ORIGINATION FORM

Proposed Revisions to a Standard Plans Index
(Please provide all information — Incomplete forms will be returned)

Index Number: 695-001
Sheet Number (s): 1 through 7
Index Title: Traffic Monitoring Sites

Index Number: 695-001
Sheet Number (s): 6-7
Index Title: Traffic Monitoring Site

LANE CONFIGURATION FOR TMS INDUCTIVE LOOP AND STRAIN GAUGE/QUARTZ AXLE SENSOR

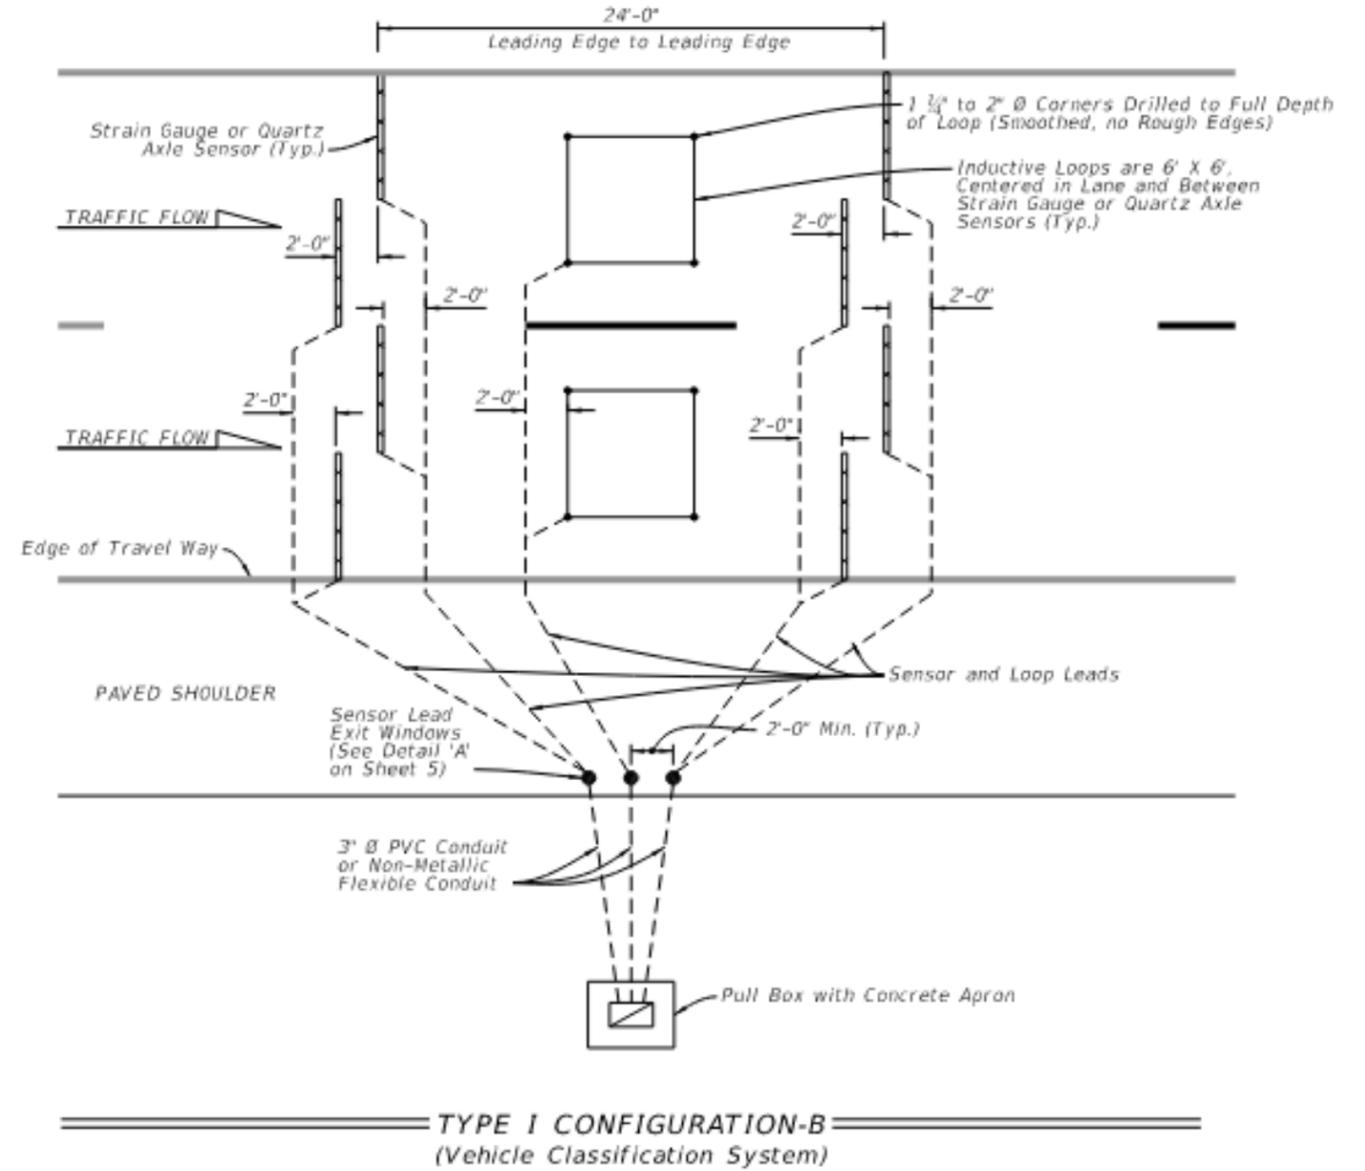
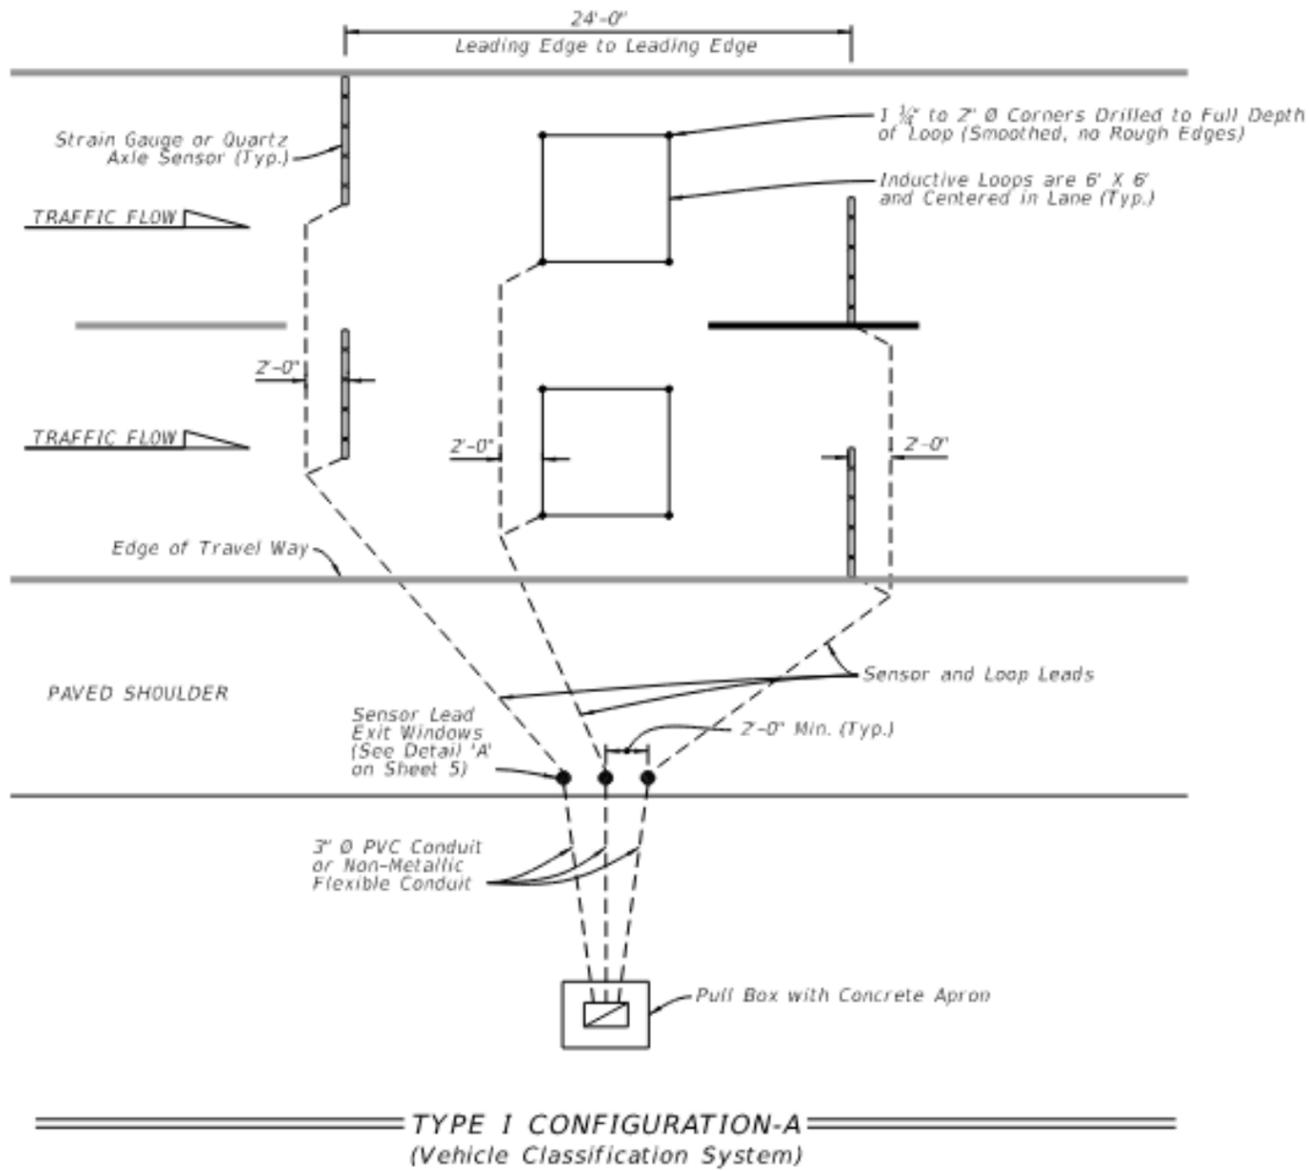
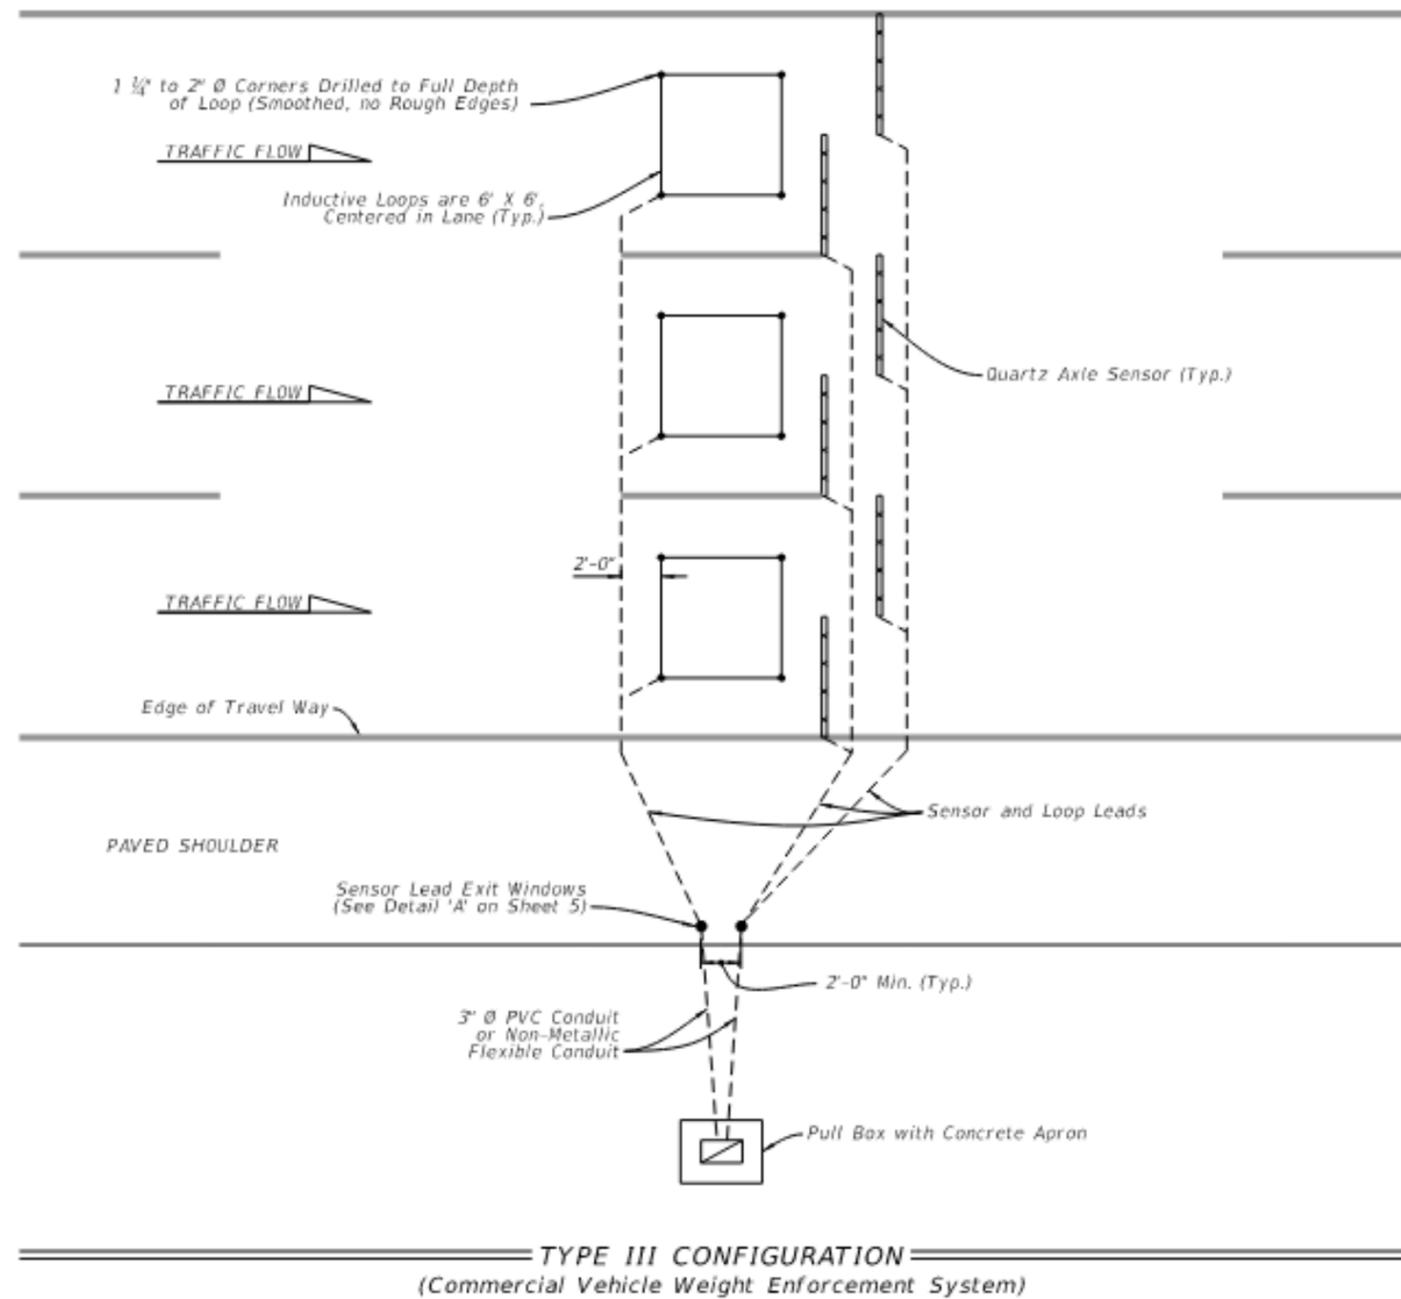
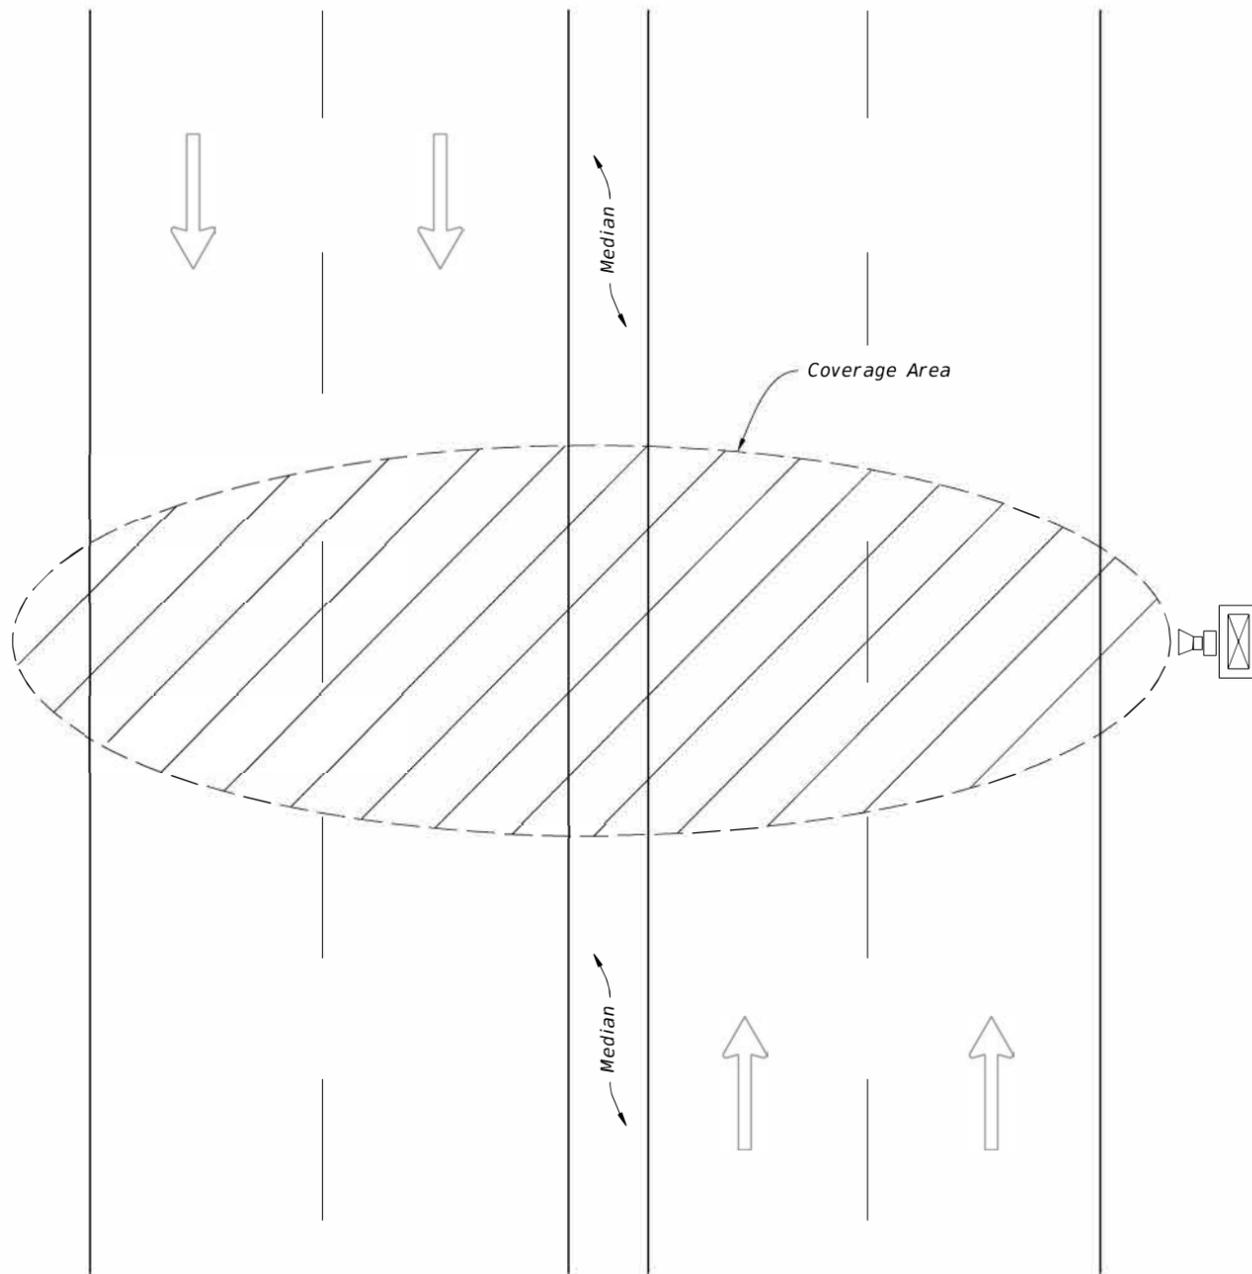
ADDED NEW DETAILS

ADDED NEW DETAILS

Configuration-A and Configuration-B are based on the vehicle Speed/classification unit. Contact the TMS Manager in the Transportation Data and Analytics Office for the correct configuration.

SOLAR POWER POLE WITH POLE MOUNTED CABINET (Telemeter Sites)

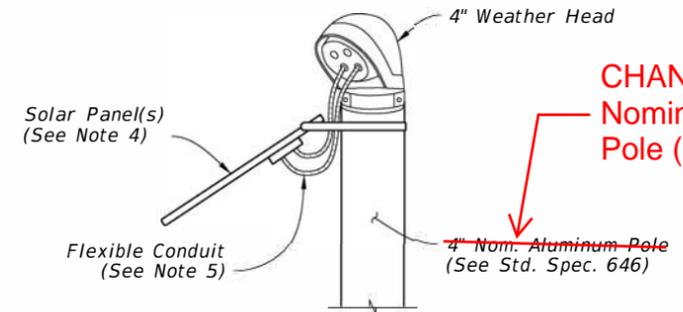
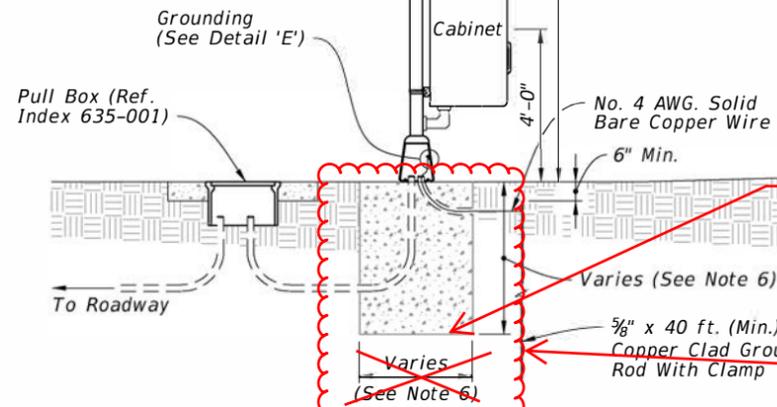
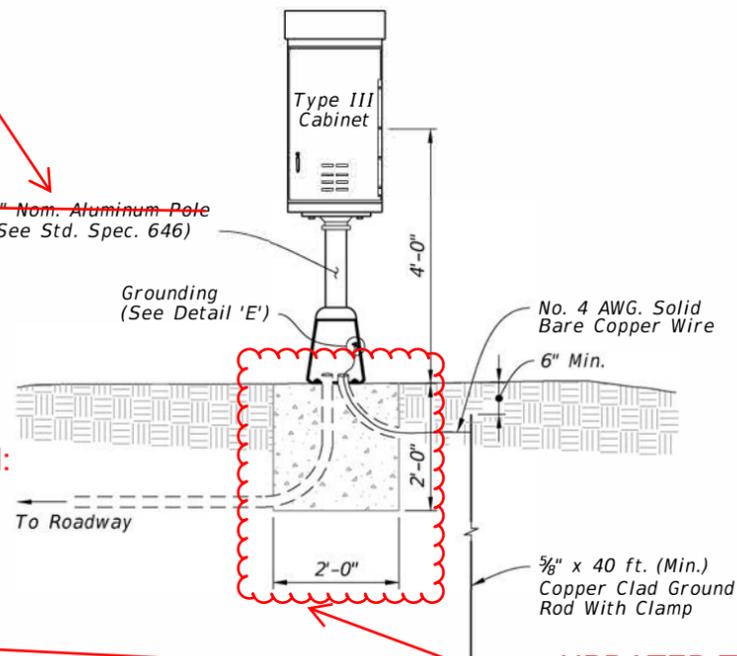
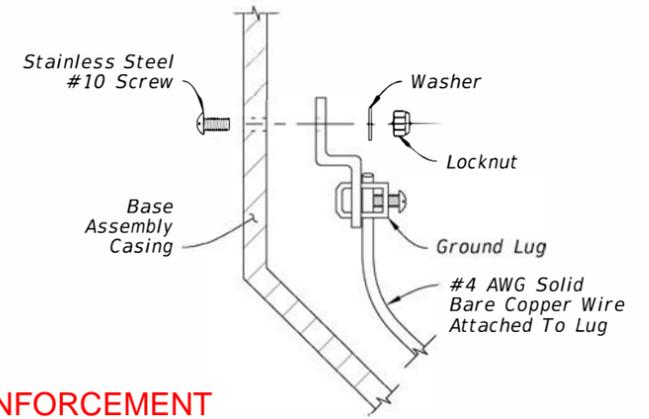
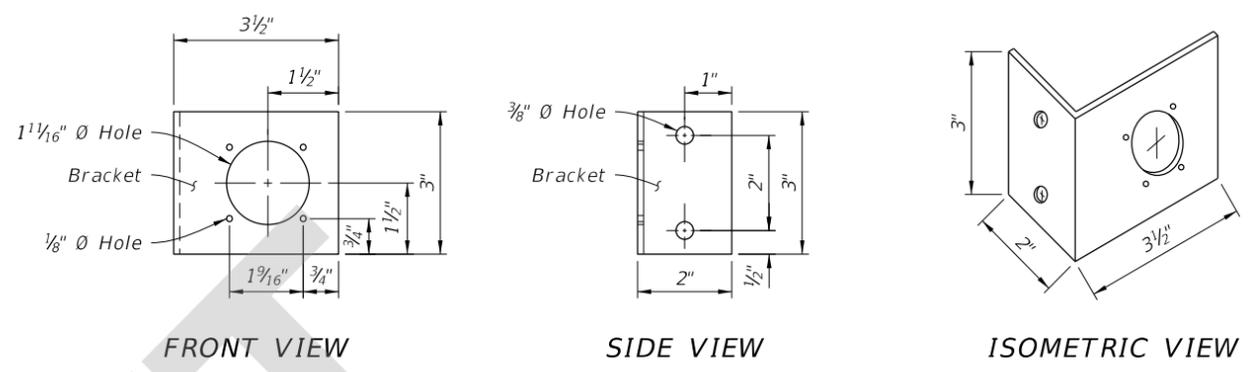
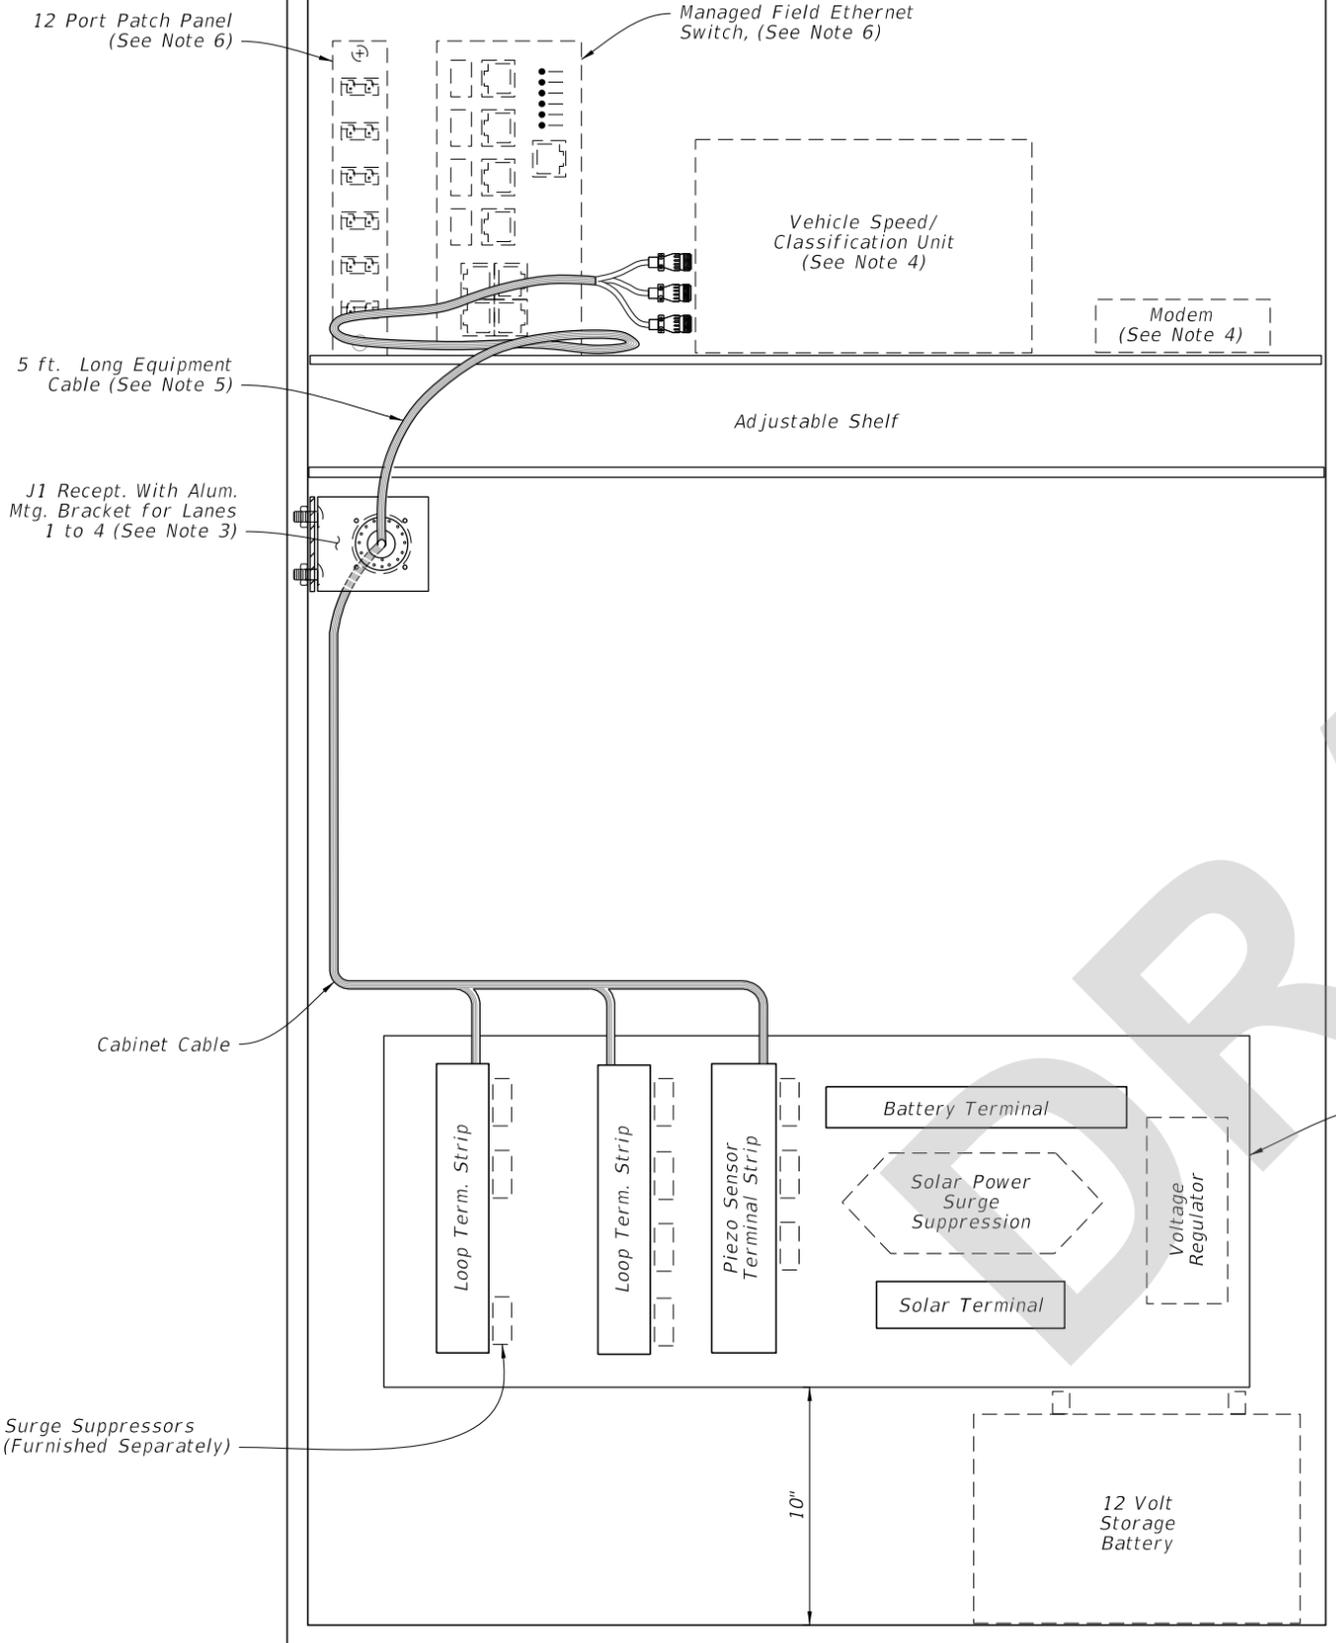
- Sheet 6 (New Sheet 8) - Update Elevation View to match foundation details on Sheet 7 (New Sheet 9); Changed "4" Nominal Aluminum Pole" to "Nominal 4" Aluminum Pole (Shc. 40) (4.5" OD)" ; Added Solar Panel callout.

- Sheet 7 (New sheet 9) - Update Foundation Details to show bars and stirrups; Update note 2 to reference Spec 646; Update Note 6; Changed all references "4" Nominal Aluminum Pole" to "Nominal 4" Aluminum Pole (Shc. 40) (4.5" OD)".

UPDATED NOTE 2: Meet the material requirements of Specification 646.

CHANGED TO:
Nominal 4" Aluminum Pole (Sch. 40) (4.5" OD)

UPDATED NOTE 6b and 6c.

CHANGED TO: Dimensions

CHANGED TO:
Nominal 4" Aluminum Pole (Sch. 40) (4.5" OD)

CHANGED TO:
Nominal 4" Aluminum Pole (Sch. 40) (4.5" OD)

CHANGED DIMENSION:
2'-0" (Dia.)

UPDATED TO SHOW REINFORCEMENT

ADDED: ELEVATION
